## S/M Fix: Fuel Pump/Sender Replacement, '03 Accord

## S/M Fix: Crankshaft Pulley Installation, '03 Accord V6

**HONDA ServiceNews**

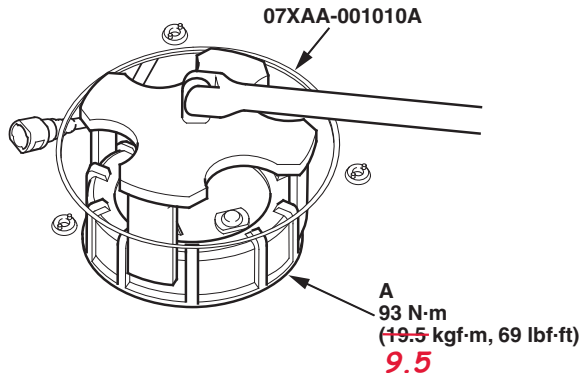
The illustration for step 7 on page 11-229 of the 2003 Accord S/M shows the wrong torque spec for the fuel pump/sender assembly locknut (A). Mark up your copies of the S/M to look like this:

7. Using the special tool, loosen the fuel pump/sender assembly locknut (A).

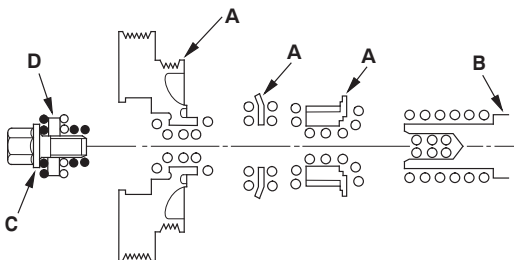
The legend for the step 1 illustration on page 6-12 of the 2003 Accord V6 Supplement S/M is wrong. Mark up your copies of the S/M to look like this:

1. Remove any oil from the pulleys (A), crankshaft (B), bolt (C), and washer (D). Clean and lubricate the points shown below.

- ~~×~~ : Clean  
● ~~×~~ : Lubricate
